Is WR1.4 Working as Intended? Case Study from TPL

Song Wang

WECC MVS meeting, May 2025

Observed Issue

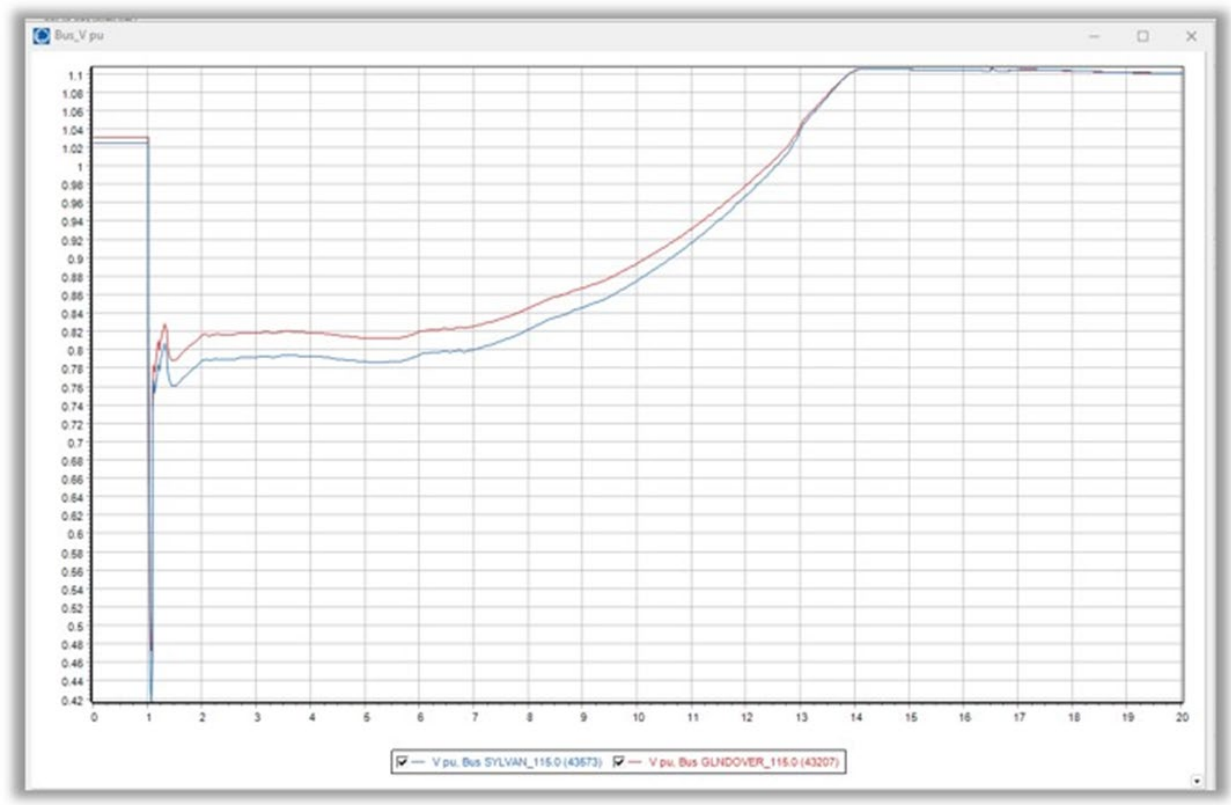
- During a P1-2 fault on a 500kV line in Northwest, two nearby buses behaved differently:
 - One 115kV (Red):
 - Recovered above 0.8 pu, then dipped again below for >2 sec → Violation triggered
 - Another 115kV (Blue):
 - Never recovered to 0.8 pu (only ~0.78 pu) → No violation triggered

- The issue isn't just waveform quality—it's how the WR1.4 logic structure fails to capture certain problematic behaviors
- “Red” Voltage looks better but is flagged
- “Blue” Voltage looks worse but is not flagged

- The logic activates the 2-second timer after recovery >80%
- Therefore, worse performance (never recovering) avoids violation
- This creates a loophole: inferior dynamics pass, while better dynamics get flagged

- Recommend WECC review WR1.4 Part 2 logic
 - Should voltages that never recover be flagged more strictly?
 - Could new logic or guidance better capture intended outcomes?
- We seek input on whether the criteria can be improved to better reflect true system performance
